**PRELIMINARY/FINAL DRAINAGE REPORT  
FOR  
REDTAIL RANCH FILING 1**

**ADDENDUM NO. 1  
APRIL 2020**

PCD Project No. SP-18-004/SF-18-021

**PRELIMINARY/FINAL DRAINAGE REPORT FOR  
REDTAIL RANCH FILING NO. 1 (Addendum No. 1)**

## DRAINAGE MAP

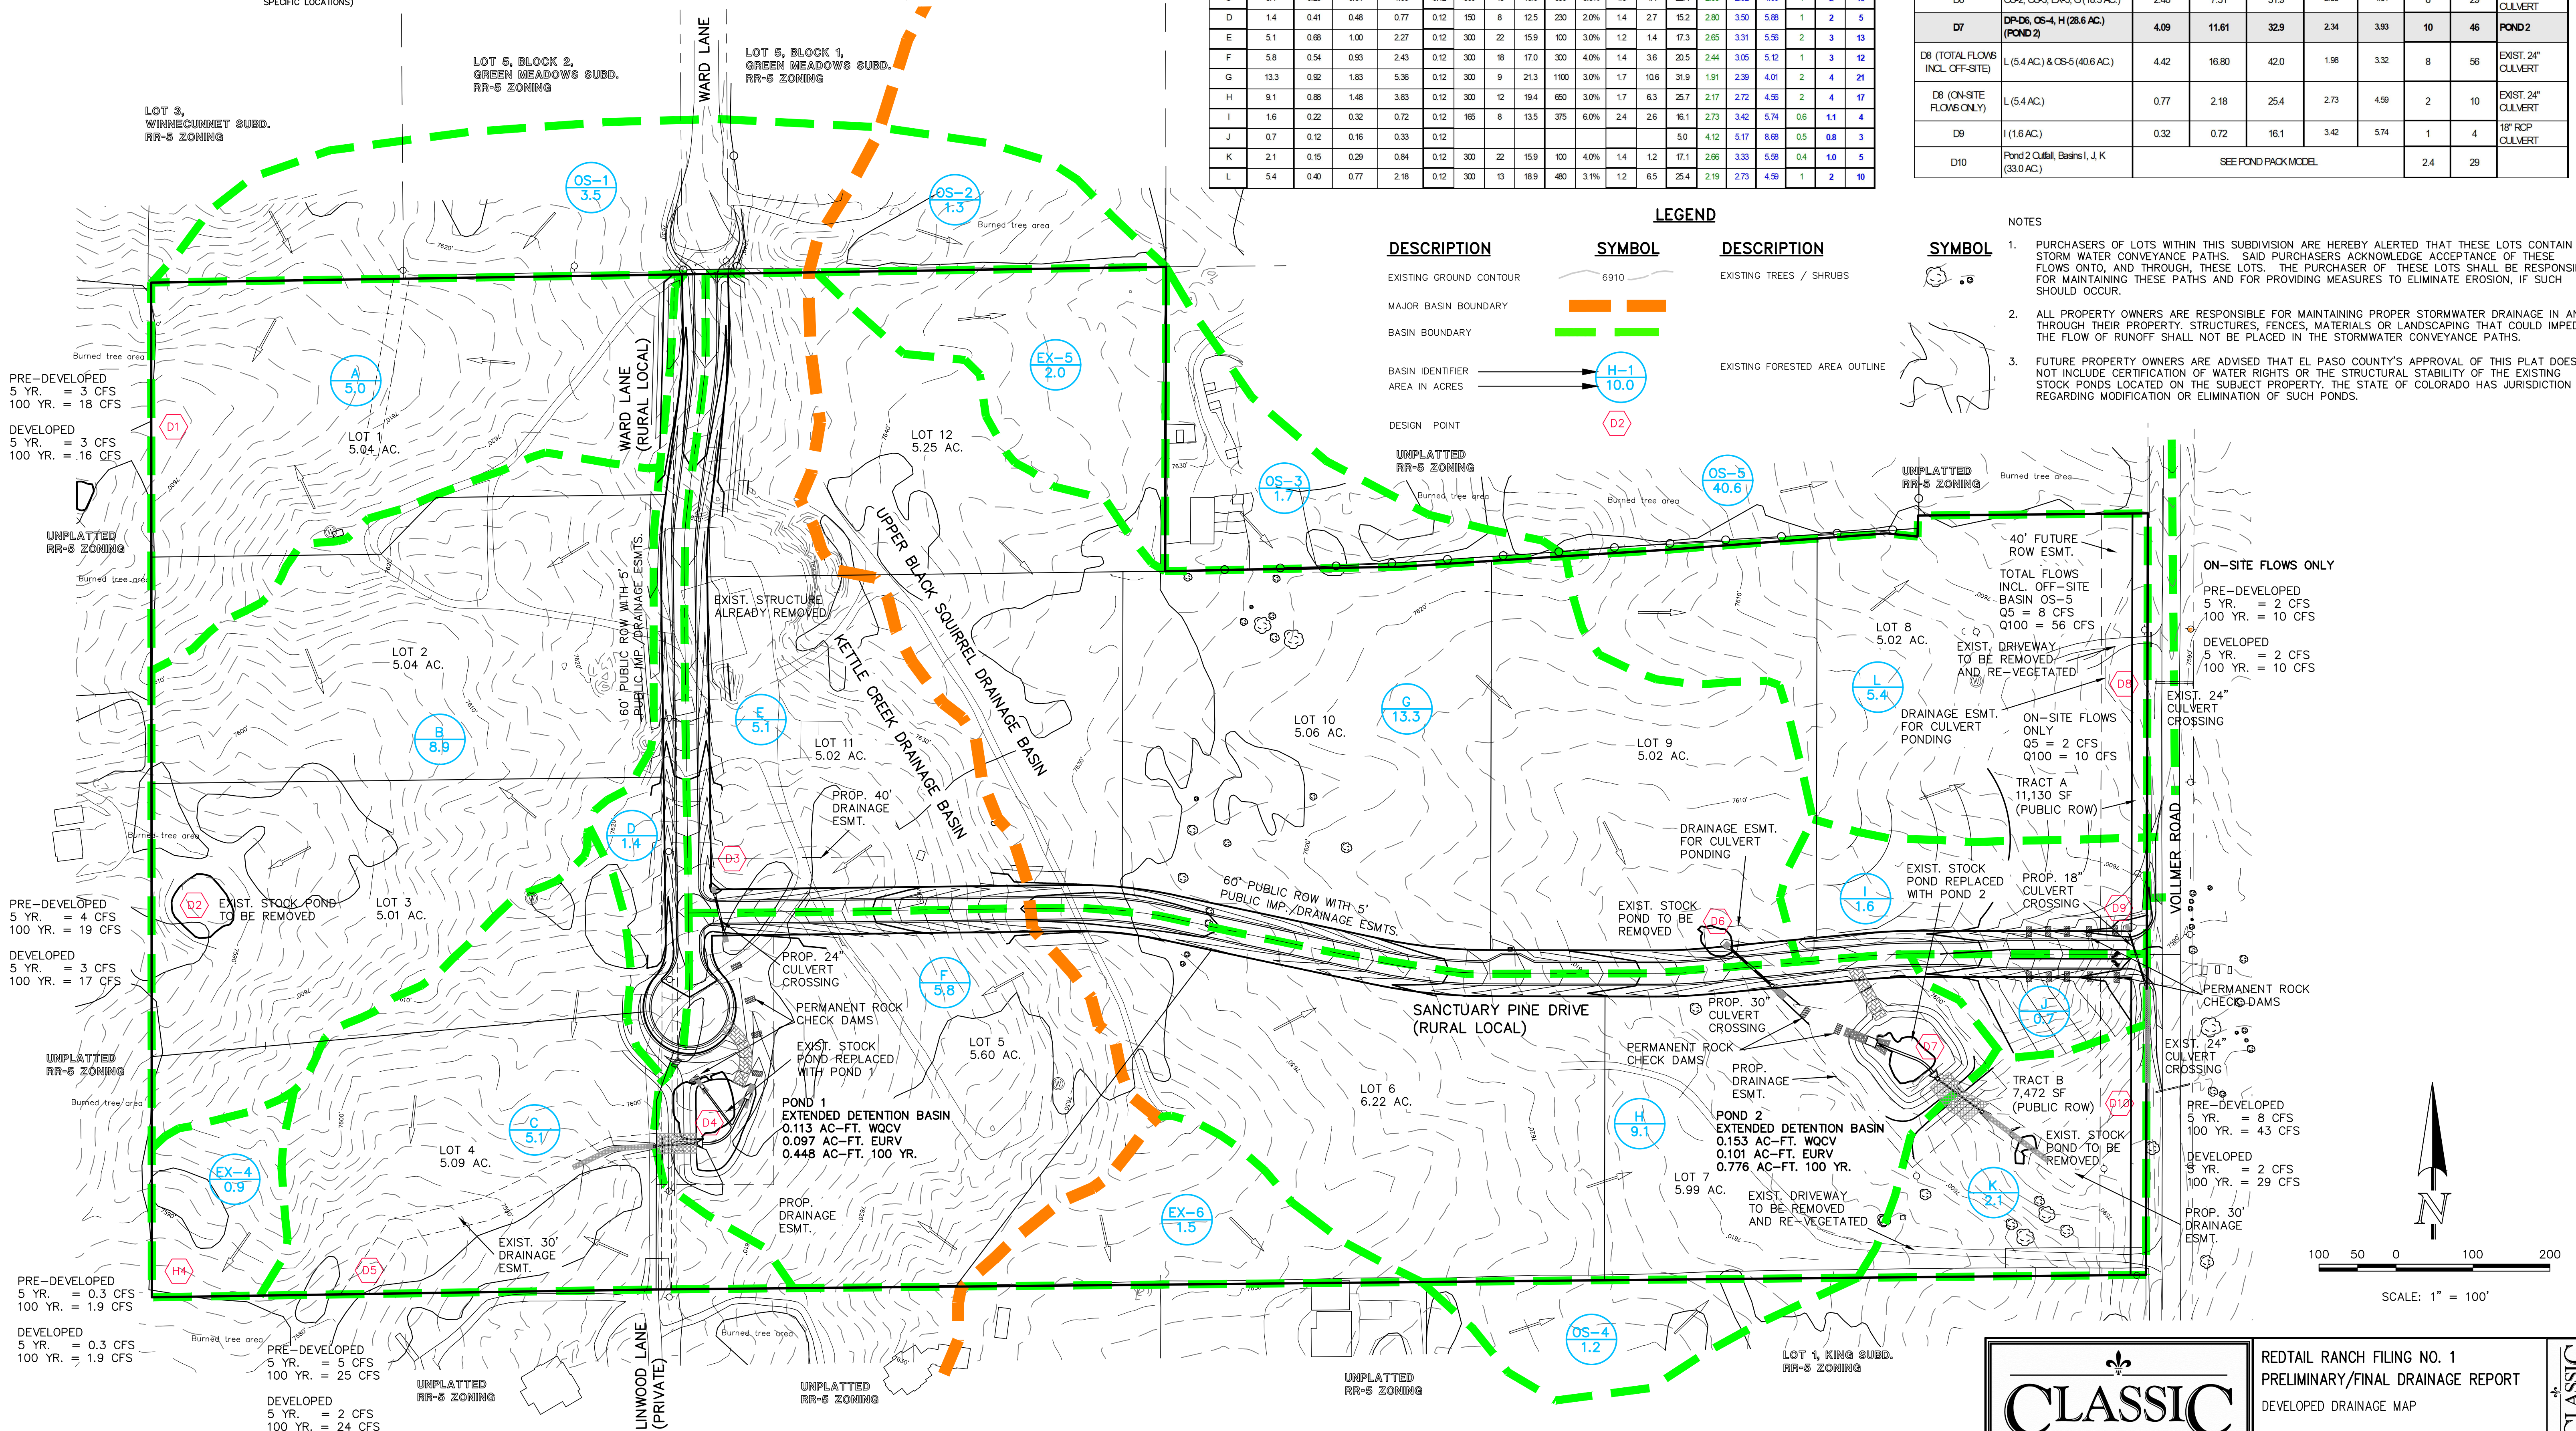
This document is Addendum No. 1 of Preliminary/Final Drainage Report for Redtail Ranch Filing No. 1. The purpose of this addendum is to revise the two stormwater quality facilities from Sand Filter Basins to Extended Detention Basins. All hydrology, pond sizing and locations remain the same as previously approved. (Reference Preliminary/Final Drainage Report Redtail Ranch Filing No. 1)

**Pond 1 (Extended Detention Basin)** has the following design parameters as a full-spectrum facility:

**Pond 2 (Extended Detention Basin)** has the following design parameters as a full-spectrum facility:

**Facility sized to release pre-development acreage of 14.8 ac. (Basin EX-3)**

**0.113 Ac.-ft. WQCV required**

**0.097 Ac.-ft. EURV required**

**0.097 Ac.-ft. EURV design with 4:1 max. slopes**

**0.448 Ac.-ft. 100-yr. storage**

**Total In-flow:  $Q_5 = 7$  cfs,  $Q_{100} = 28$  cfs**

**Pond Design Release:  $Q_5 = 0.05$  cfs,  $Q_{100} = 13.8$  cfs**

**Pre-development Release:  $Q_5 = 0.30$  cfs,  $Q_{100} = 17.6$  cfs**

**0.153 Ac.-ft. WQCV required**

**0.101 Ac.-ft. EURV required**

**0.254 Ac.-ft. EURV design with 4:1 max. slopes**

**0.78 Ac.-ft. 100-yr. storage**

**Total In-flow:**

**$Q_5 = 10$  cfs,  $Q_{100} = 46$  cfs**

**Pond Design Release:**

**$Q_5 = 0.10$  cfs,  $Q_{100} = 20.7$  cfs**

**Pre-development Release:**

**$Q_5 = 0.49$  cfs,  $Q_{100} = 29.9$  cfs**
